# MAYOR & COUNCIL AGENDA COVER SHEET

Resolution of the Mayor and City Council Granting Approval of Road Code Waivers for Variable Paving Widths and Reduced Centerline Radii for the Hidden Creek Land Bay III Development Schematic Development Plan SDP-01-006- RC-29

RESOLUTION OF THE MAYOR AND CITY COUNCIL  
GRANTING APPROVAL OF ROAD CODE WAIVERS FOR  
VARIABLE PAVING WIDTHS, STREET SECTIONS,  
AND REDUCED CENTERLINE RADII FOR  
THE HIDDEN CREEK LAND BAY III DEVELOPMENT  
SCHEMATIC DEVELOPMENT PLAN SDP-01-006

## SCHEMATIC DEVELOPMENT PLAN WAIVER REQUEST PLAN

# HIDDEN CREEK LB. III

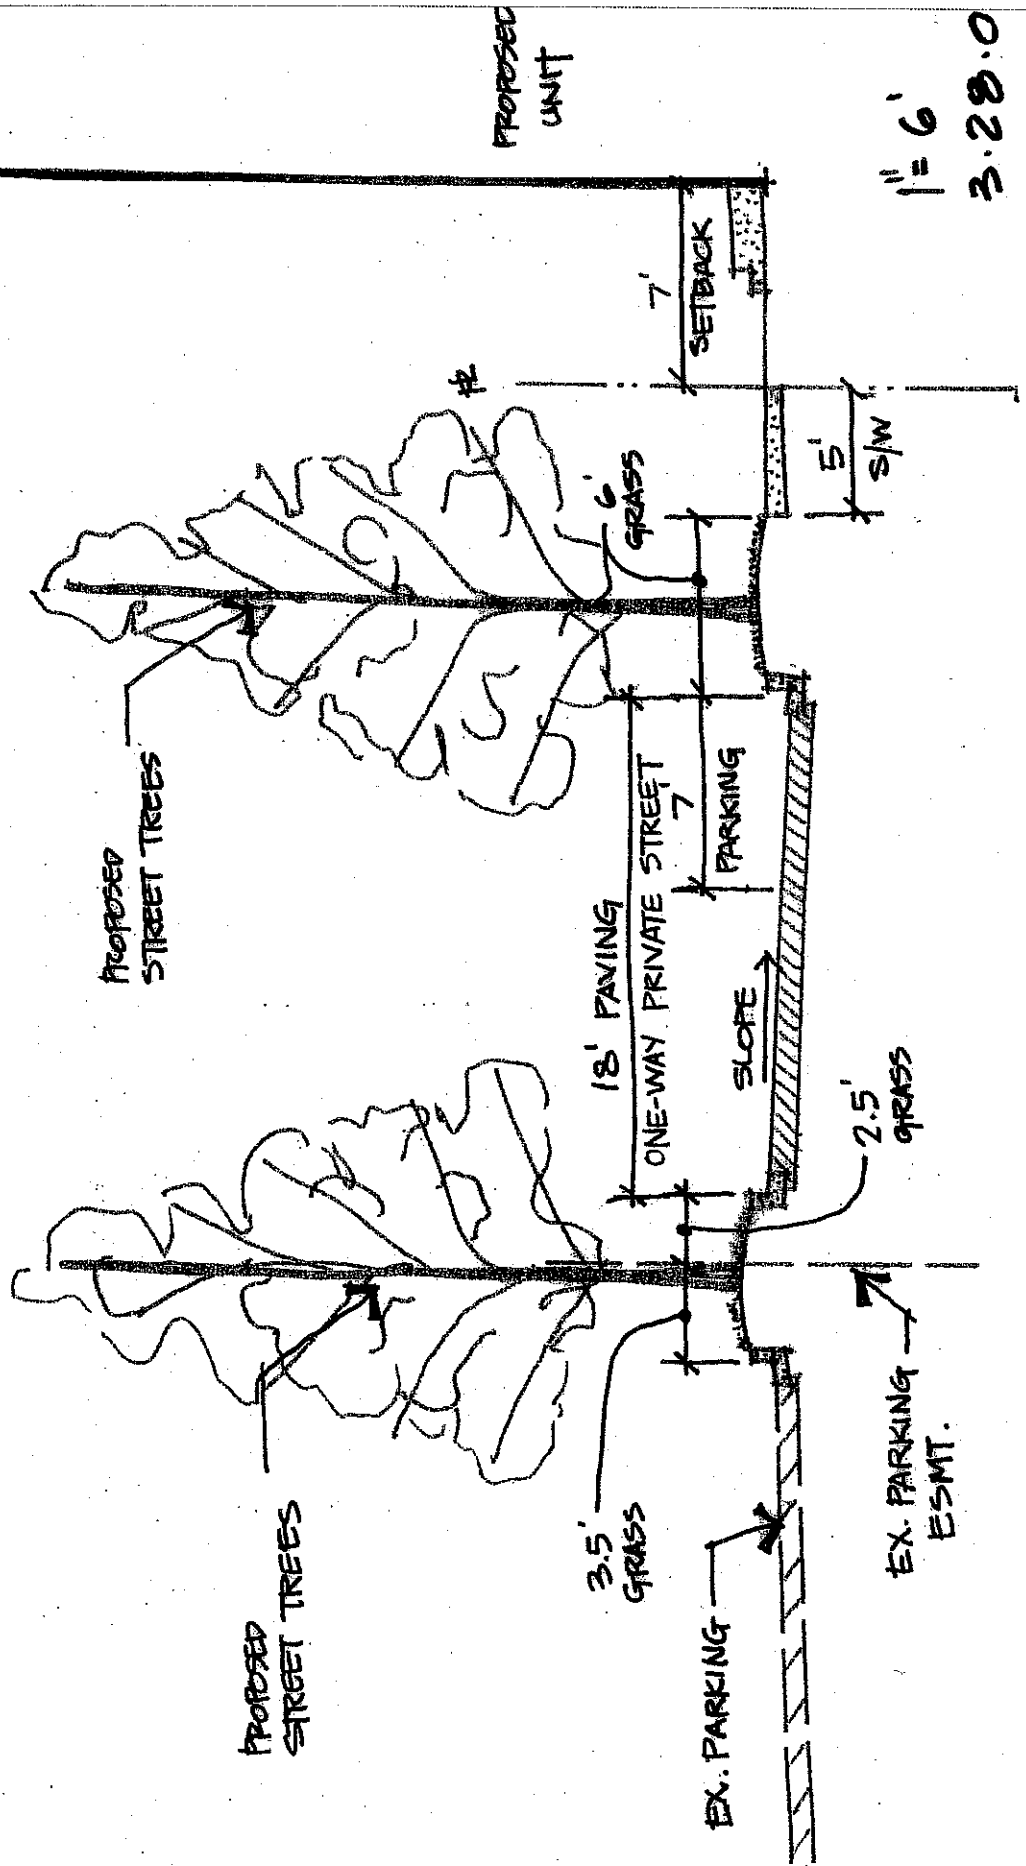
Based on continued discussions between the Applicants and City Staff, a need has been identified to widen the proposed minimum 20-foot paving width to 26-feet in the area of the 50-foot centerline radius proposed at several locations within the project as shown on the Waiver Request Plan submitted as a part of the SDP application. Specifically, by widening the roadway paving width from 20 feet to 26 feet, the Applicants will provide sufficient paving width to safely accommodate larger vehicles on the roadway in the vicinity of the 50-foot centerline radius. Vehicles traveling in the opposite direction will now have sufficient room to move around larger vehicles that might be encountered at curves along the roadway. The Mayor and Council approved this same configuration for Hidden Creek Land Bay I.

In addition, this letter requests a waiver of the City's standard 34-foot street section to allow a short segment of roadway to be built as an 18-foot paved section with parallel parking on one side to serve one-way traffic only. The one-way road segment is located next to the existing parking area serving the adjacent shopping center. The parking area is located within an easement on the Hidden Creek property and therefore cannot be removed at this time. A diagram illustrating the proposed section (identified on the SDP as Alley GG) is enclosed. As shown on the enclosed diagram, the proposed street section also includes two 6-foot wide planting strips, street trees on both sides, and a 5-foot wide sidewalk in front of the units.

into and record an agreement with the City to dedicate, design and escrow funds or other security for the full construction of the one-way road to the City's standard 34-foot section for two-way traffic. This construction would be done by others using the escrowed funds when the parking easement is released.
